**CITY OF PORTLAND, MAINE
DEVELOPMENT REVIEW APPLICATION
PLANNING DEPARTMENT PROCESSING FORM**

RE: 150 Evergreen Drive Micucci Bros. Site Plan

TO: Candy Talbot, Planning Technician
FROM: Tony Lombardo, Project Engineer, *TL*
DATE: April 29, 1996
SUBJECT: Micucci Wholesale Foods, Lot 14, Industrial Way

TO: Kandice Talbot, Planning Technician
FROM: James Seymour, Acting Development Review Coordinator *JRS*
DATE: May 14, 1996
RE: Micucci Bros. Industrial Way Site Plan - Workshop Comment

SITE PLAN "A"
WITH LAY OUT, UTILITIES & TOPO

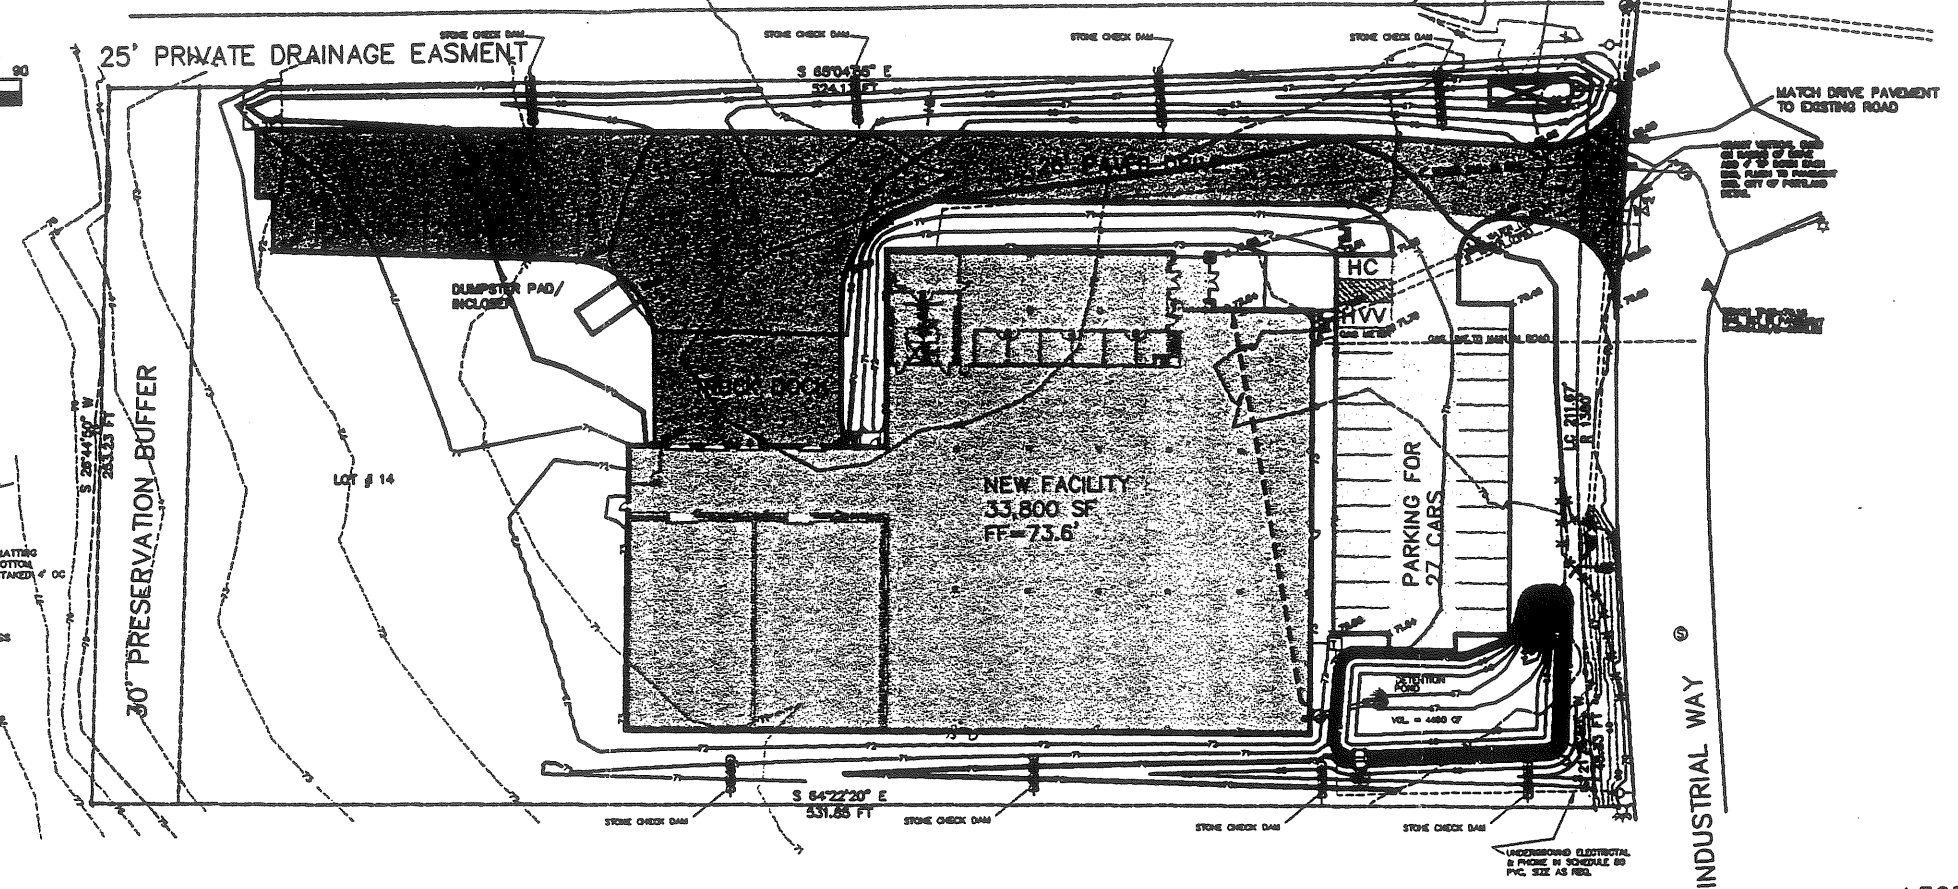
- It appears that the majority of runoff generated from the proposed 27-car parking area is allowed to drain into Industrial Way. The proposed grading should be revised to direct all of this runoff towards either the proposed detention basin or towards the ditch along the northeasterly boundary.

4. There appears to be a significant amount of offsite contributed runoff sheet flowing across the rear parking area and truck turnaround. This area shall be constructed to either divert drainage to one of the side line ditches or collect and convey the runoff by a culvert or catch basin to the north side ditch. This area subject to sheet flow travelling across the parking area could be a severe icing problem during winter months and may eventually deteriorate the binder course of pavement through continuous saturating conditions.

The entire stormwater plan is based on the fact that the building runoff, which is in excess of half of the total impervious surface area is being detained. Thus, the other paved areas are draining to the existing drainage ways. We feel that it is most appropriate to pitch the parking in the direction that it is being pitched. We are sending the water to the existing swale, at which point the stormwater will enter the piping system already on site and head towards the existing detention basin. We believe that this is the most appropriate approach rather than draining the water into the pond. Secondly, draining in the opposite direction would force all the water out the entry drive and across the driveway. Given the constraints, this is the best scenario.

OUTLET STRUCTURE
SCALE= NTS

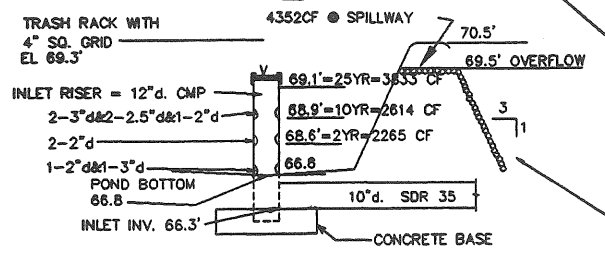
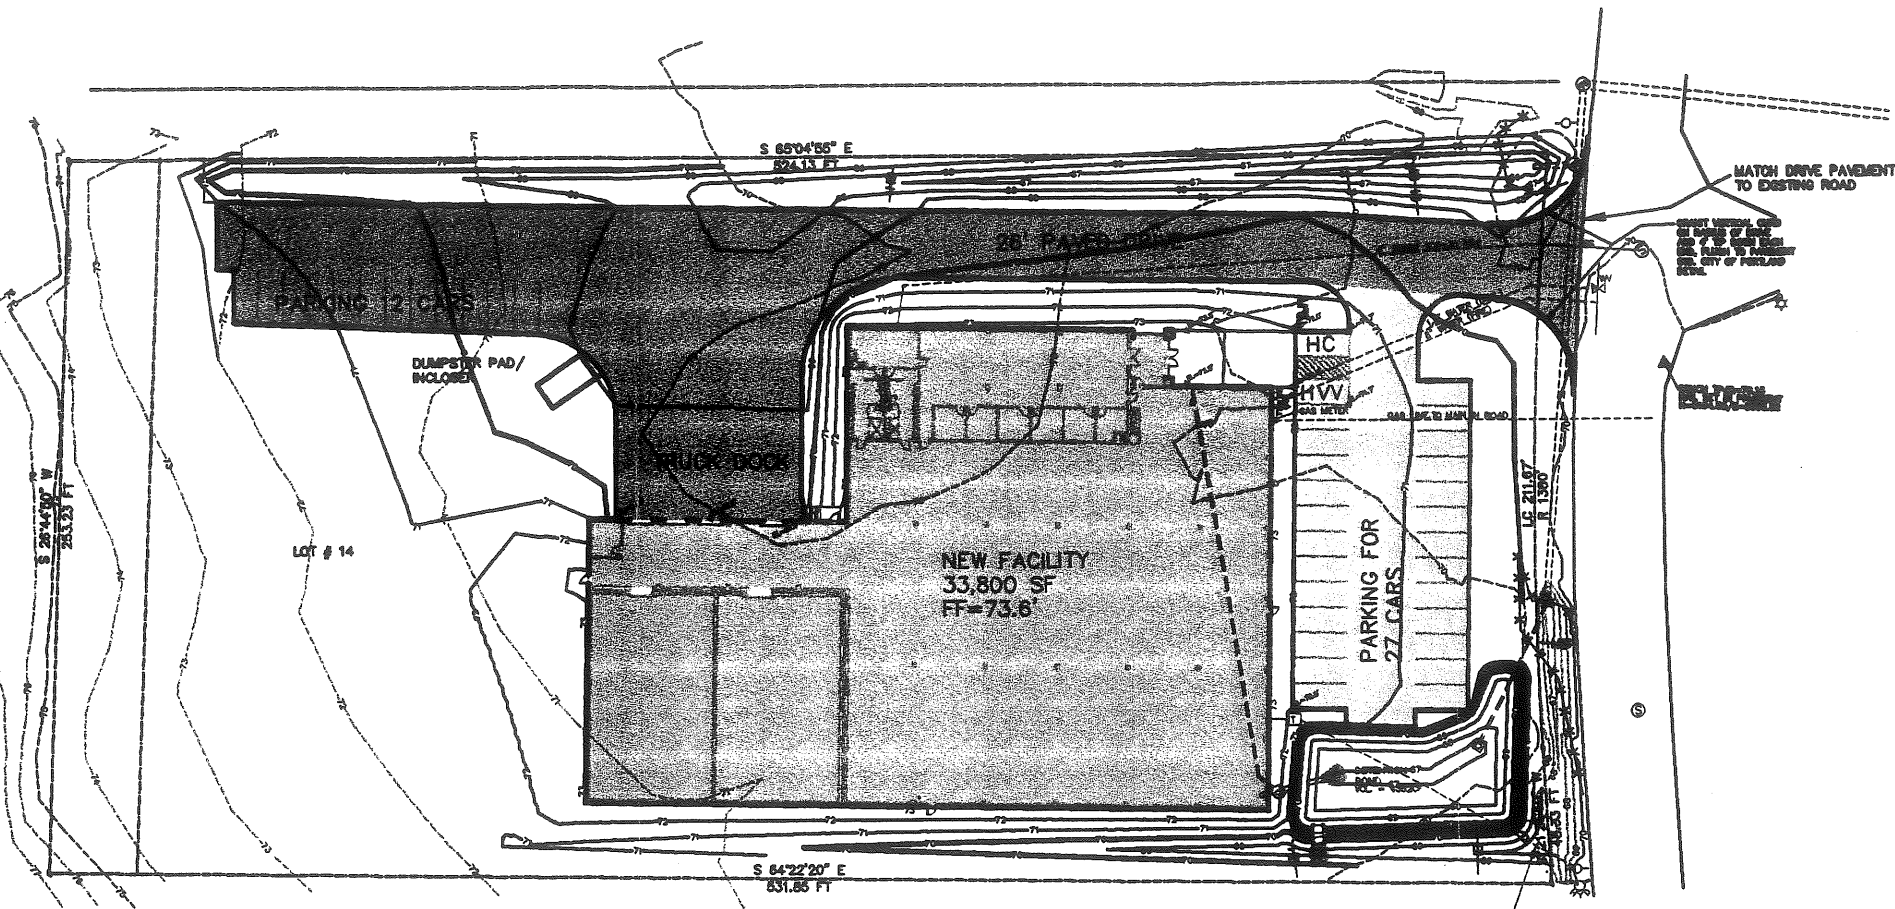
3. The detention pond construction should include notes and details indicating soil depths, riprap depths, berm construction including a keyed section and soil materials, the emergency spillway should outlet into the road ditch instead of the property line ditch which abuts lot 15, the 10" outlet pipe should outlet further away from the 24" concrete culvert than what was shown, and details of the pipe trench shall be added. Also, I would suggest that the underground electrical not be installed through the detention pond. Other options are available and appear to be safer. Central Maine Power may need an easement around the transformer pad and may suggest a preferred location.

- A detention pond construction detail should be provided which includes notes and specifications for soil depths, berm construction, depth of riprap for spillway and construction specifications for emergency spillway.
- Outlet structure detail should specify dimensions for concrete base.

3. I have reviewed the stormwater calculations and believe that they are acceptable. I have concerns about the pond outlet being so close to the driveway culvert inlet. I disagree with an outlet and inlet being so close together and I suspect that area between the two pipes is subject to a significant amount of turbulence and erosion potential. The applicant should consider either regrading the ditch area or provide more stabilization to both pipe ends, to accommodate the erosion potential.

The detention pond detail of the berm. We have added some notes to the plan which we hope will clarify this.

As stated in my letter of May 1, 1996, we are not relocating the overflow spillway. We feel that it is in the most appropriate location. Additionally, we are moving the outflow pipe for the pond, slightly upgrade from the existing 24" storm drain pipe (see revised plans). Our consultants concur with this location of the piping.
